SUBJECT: REQUEST FOR ADDITIONAL INFORMATION REGARDING PRESSURIZED  
WATER REACTOR OWNERS GROUP TOPICAL REPORT WCAP-17788,  
"COMPREHENSIVE ANALYSIS AND TEST PROGRAM FOR GSI-191  
CLOSURE" (TAC NO. MF6536)

Enclosure:  
WCAP-17788, Volume 4 RAI  
Questions (Non-Proprietary)

REQUEST FOR ADDITIONAL INFORMATION  
RELATED TO VOLUME 4 OF TOPICAL REPORT WCAP-17788,  
“COMPREHENSIVE ANALYSIS AND TEST PROGRAM FOR GSI-191 CLOSURE”  
PRESSURIZED WATER REACTOR OWNERS GROUP  
TAC NO. MF6536

Figure 1: Predicted Break Exit Qualities for Case 1 to Determine  $t_{block}$  for the CE Plant Category  
(Top: original result from WCAP-17788 Rev. 0 with  $t_{block}=15,000$  s = 250 min  
Bottom: corrected result from WCAP-17788, Erratum, OG-16-42 with  $t_{block}=20,000$  s = 333 min)

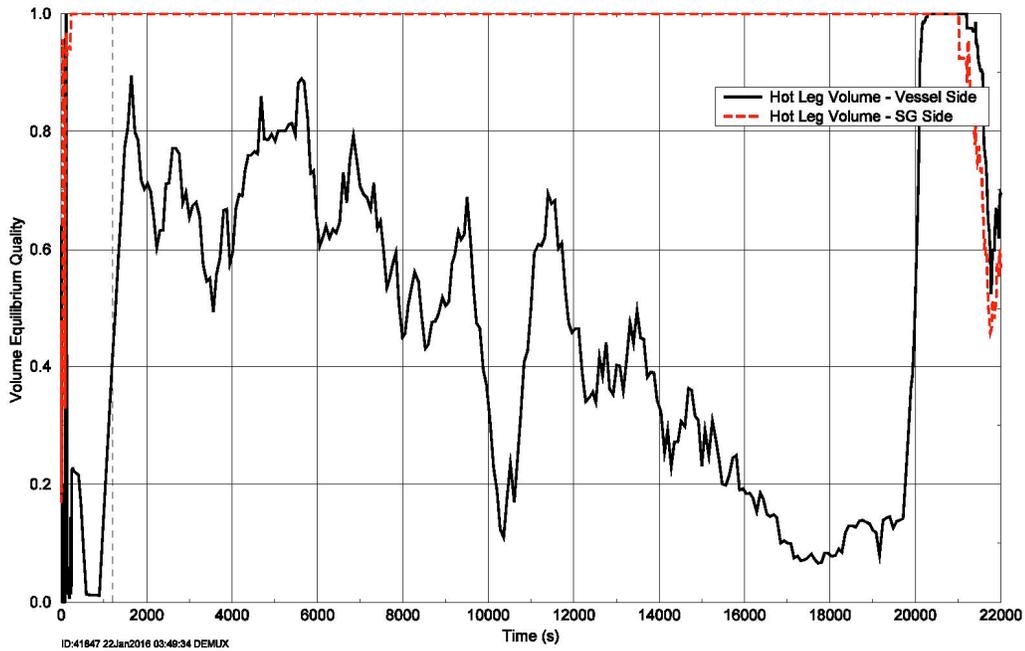
- iv. Predicted pressure difference between the upper plenum cell connected to the broken hot leg pipe and the containment backpressure.
- f. Figure 1 below compares predicted exit qualities for the original analysis of Case 1 used to determine  $t_{\text{block}}$  for the CE plant category as documented in Section 10 and the revised analysis in Erratum, submitted with the February 12, 2016, letter OG-16-42 ( $t_{\text{block}}=20,000$  seconds). It is noted that the results are significantly different following the simulated blockage time in each analysis. The results also differ during some time periods prior to 15,000 seconds, which is the earlier of both simulated  $t_{\text{block}}$  times. Describe why the results prior to 15,000 seconds are not consistent between the two cases and state which case presents the correct values. Provide similar information for the time period after blockage is simulated. Please describe why the results fluctuate significantly and justify that the code performance provides a valid representation of the system.

- h. Investigate whether the substantial scatter in the  $m_{\text{split}}$  results shown in Figure 10-5 is related to the behavior of the break liquid carry-out result. Note that if the liquid carryover is incorrect, it can render the  $m_{\text{split}}$  result unacceptable. Describe whether correction of the  $m_{\text{split}}$  results was found necessary to address the observed scatter if it was determined that effects from deficiencies in the predicted liquid entrainment were a contributing factor. Provide any updated result if applicable.
